# UNITED STATES PATENT AND TRADEMARK OFFICE

APPLICATION NO.	FILING DATE	FIRST NAMED INVENTOR	ATTORNEY DOCKET NO.	CONFIRMATION NO.
09/864,389	05/25/2001	Jacob Richter	2390/49704	1194
27123	7590	08/10/2005	EXAMINER	
MORGAN & FINNEGAN, L.L.P. 3 WORLD FINANCIAL CENTER NEW YORK, NY 10281-2101			BUI, VY Q	
			ART UNIT	PAPER NUMBER
			3731

**Office Action Summary**

DETAILED ACTION

*Fig. 30*

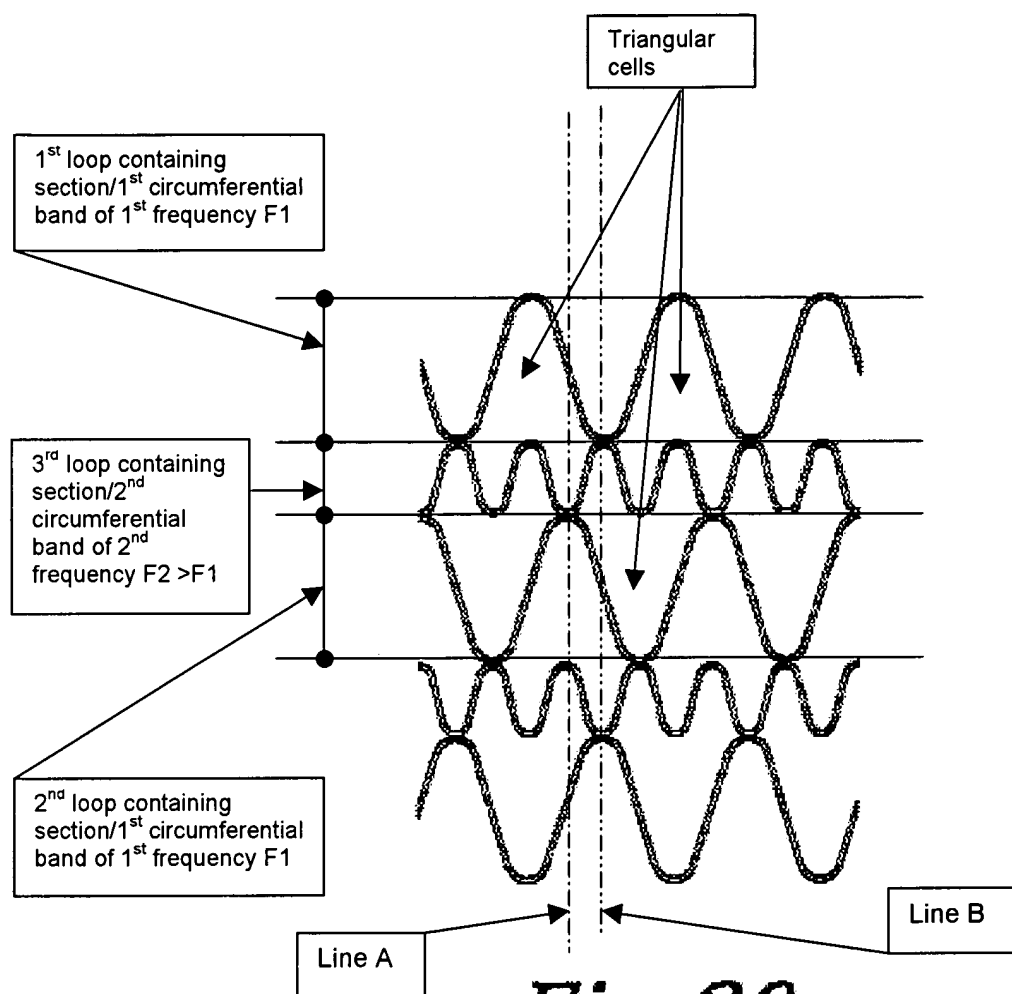
As to claims 1, 6, 11, 42-47 and 49, JAYARAMAN (see Fig. 30 on page 3 above) shows a stent structure comprising 1<sup>st</sup> and 2<sup>nd</sup> loop containing sections/1<sup>st</sup> circumferential bands of a frequency F1, 3<sup>rd</sup> loop containing sections/2<sup>nd</sup> circumferential bands of 2<sup>nd</sup> frequency F2 > F1 to define cells/triangular cells as recited in the claims:

a. 3<sup>rd</sup> loop containing sections are configured in a sinusoidal shape of a frequency F2 higher than a frequency F1 of 1<sup>st</sup> and 2<sup>nd</sup> loop containing sections (Fig. 30, page 3 above), therefore 3<sup>rd</sup> loop containing sections do expand or contract when the stent structure is bent/expanded, thus 3<sup>rd</sup> loop containing sections do contribute to the cells elongating or shortening when the stent is in a curved configuration/expanded configuration.

b. Cells/triangular cells in one side of a neutral axis of bending of the JAYARAMAN stent will be in a tension condition and in the other side of the neutral axis will be in a compression condition. Cells under the tension condition will open in length and narrow circumferentially and cells under the compression condition will shorten in length but widen circumferentially.

c. In an collapsed configuration for deployment/before expansion, lines A and B are substantially closed one to another to make two low frequency adjacent bands out of phase 180° as recited in the claims.

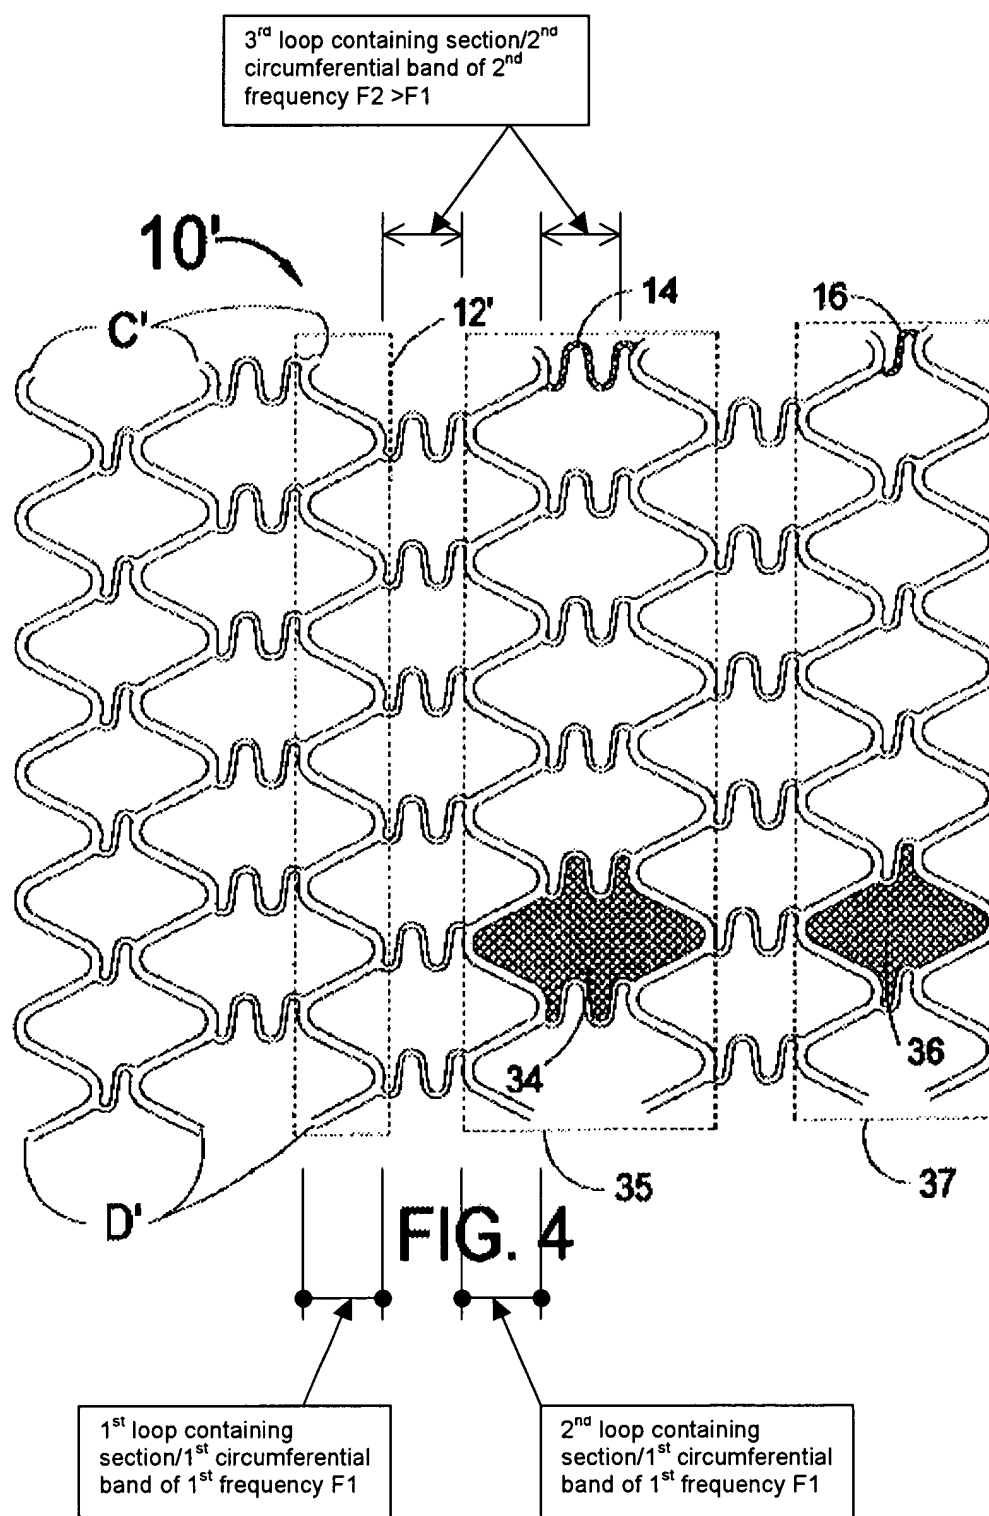
1. Claims 1, 6, 42-47 and 49 are rejected under 35 U.S.C. 102(e) as being anticipated by Fischell-6,190,403.

Please refer to Fischell's Fig. 4 reproduced and shown in page 4 of this "Office Action". Fischell-'403 (Fig. 4) disclose substantially all structural limitations of the claimed invention. Notice that there is no limitation in the claims to specify what is the scope of the claims by the term "oriented". Because 1<sup>st</sup> loop containing sections/1<sup>st</sup> circumferential bands of frequency F1, 2<sup>nd</sup> loop containing sections/1<sup>st</sup> circumferential bands of frequency F1, and 3<sup>rd</sup> loop containing sections/2<sup>nd</sup> circumferential bands of frequency F2>F1 extend in circumferential direction of the stent 10' and have a circumferential dimension, therefore, it would be reasonable to consider the 3<sup>rd</sup> loop containing sections/2<sup>nd</sup> circumferential bands as being oriented in a circumferential direction of the stent 10'. Further, if there is no explicit definition of a specific term, such as the term "oriented" as recited in the claims, one cannot transport the specification into the claims.
